Planning Officer: Carl Ewin  
Direct Phone: 074086 4656  
Our Reference: OPW/25/0003  
Your Reference: LU23112

## **Decision Notice**

Application No: OPW/25/0003  
Street Address: 405 Chewko Road, Mareeba  
Real Property Description: Lot 71 on SP292140  
Planning Scheme: Mareeba Shire Council Planning Scheme 2016

Type of Decision:	Approval
Type of Approval:	Development Permit for Operational Works (Internal/External Roadworks, Earthworks, Stormwater, Water Supply and On-site Carparking for Two Rivers Community School – Development Permit MCU/23/0012)
Date of Decision:	19 August 2025

**FOR APPROVAL** LU23112-2-CD-202 A

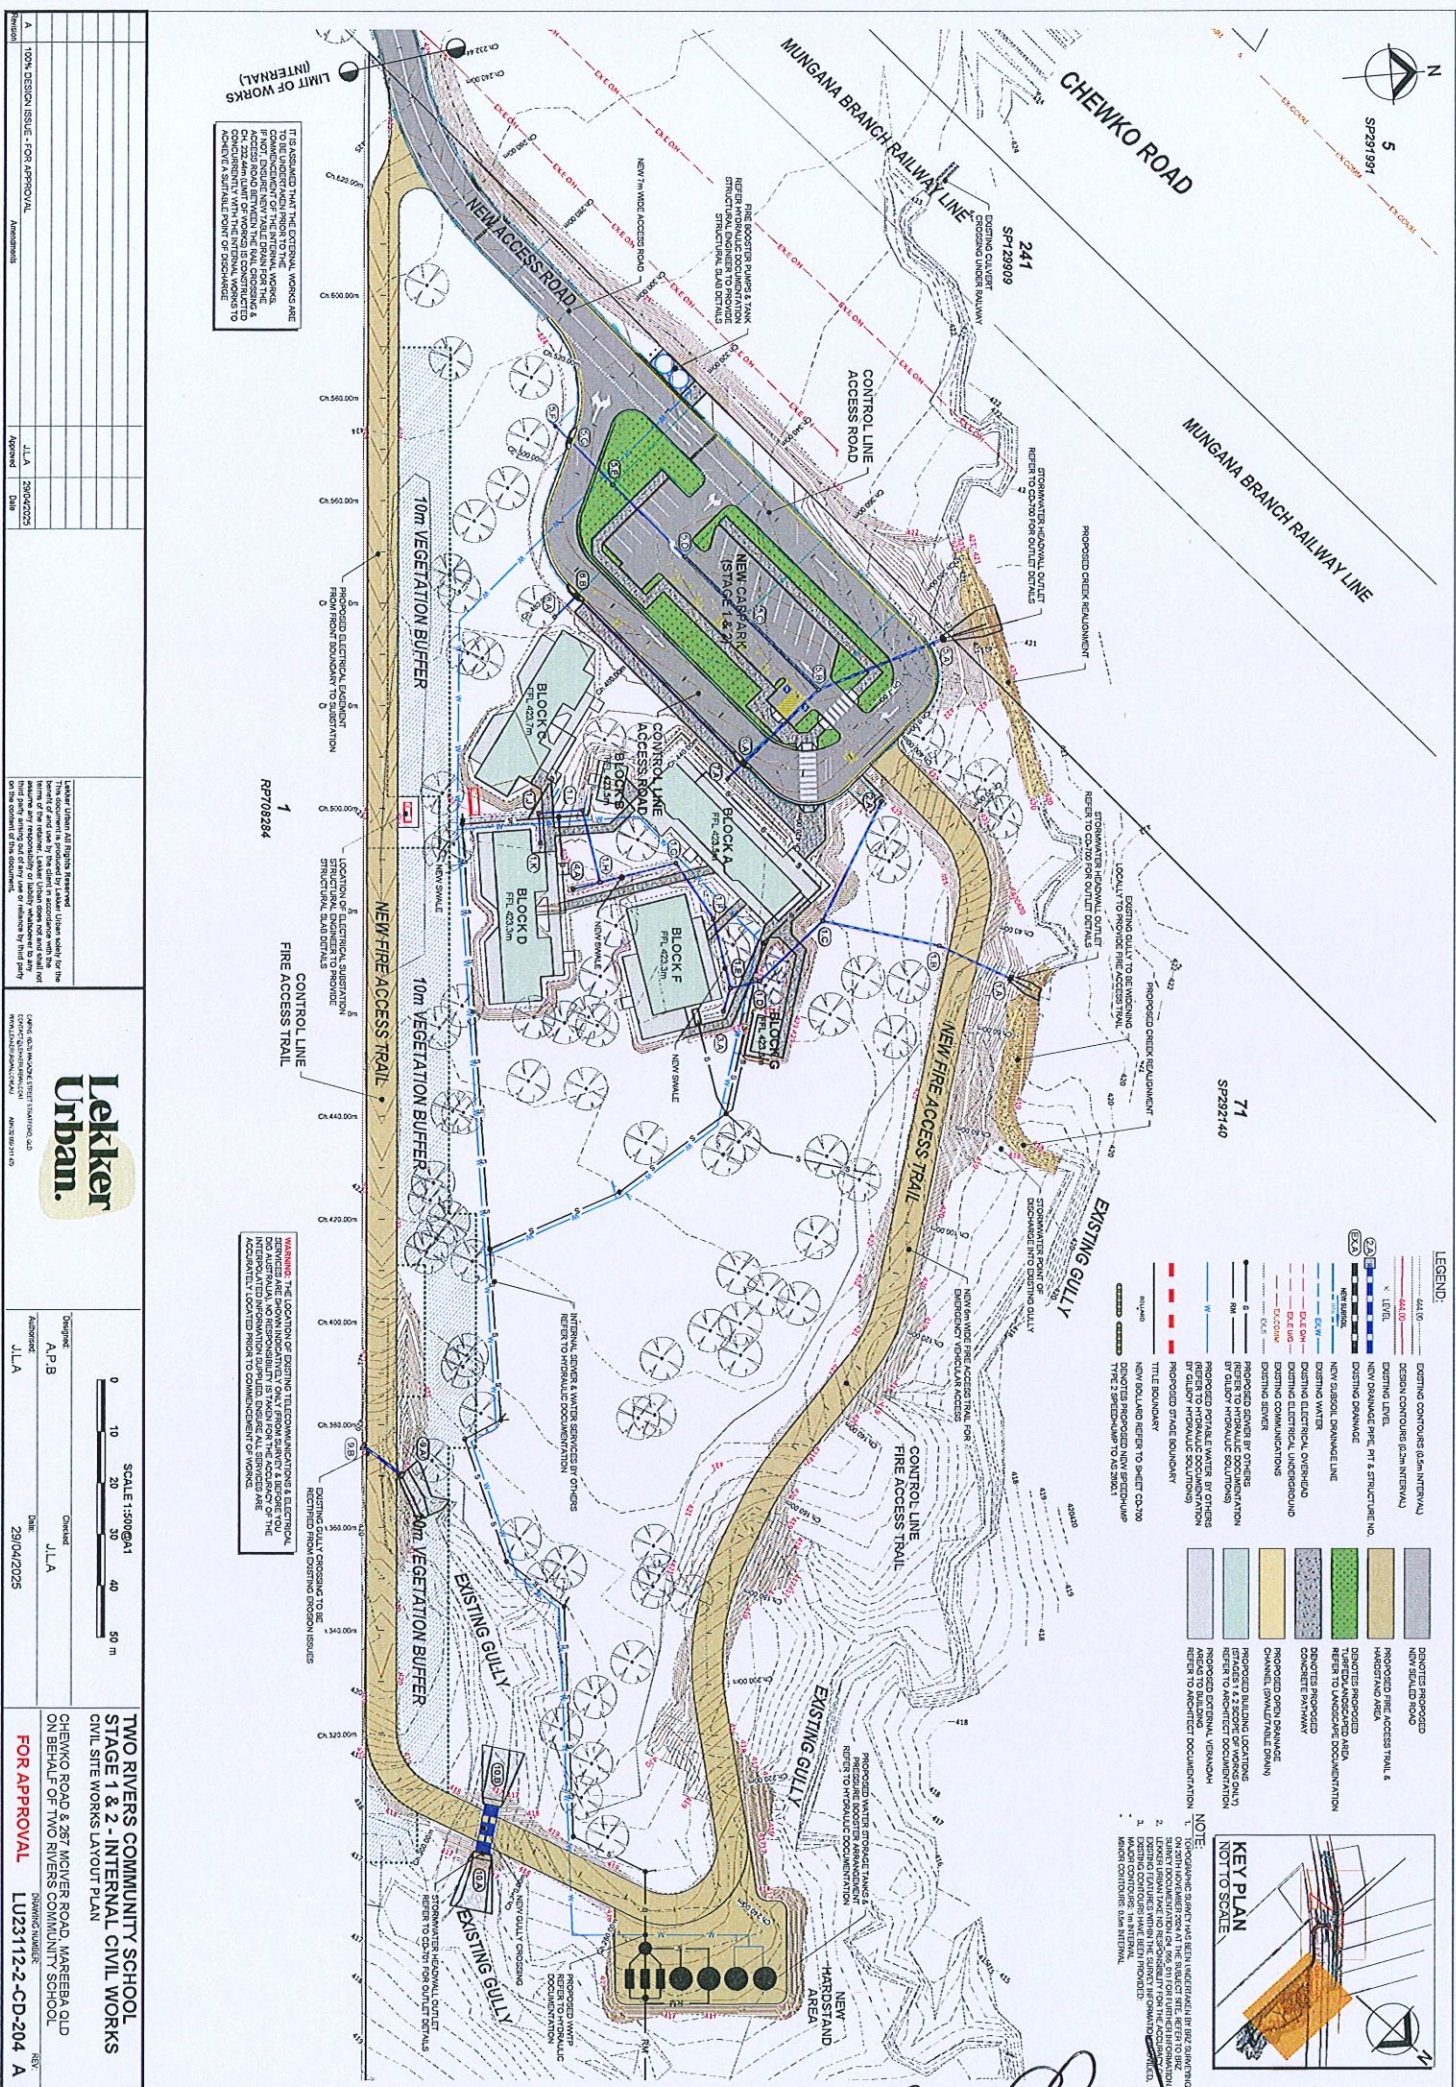
- The notation on plan no. *LU23112-1-CD-202* must be amended to reference *LU23112-1-CD-203* and not *LU23112-1-CD-204*.
- A notation must be added to plan no. *LU23112-2-CD-203* stating that owners consent must be obtained from the owners of Lot 1 on RP708284 prior to any earthworks occurring that may impact on this allotment.
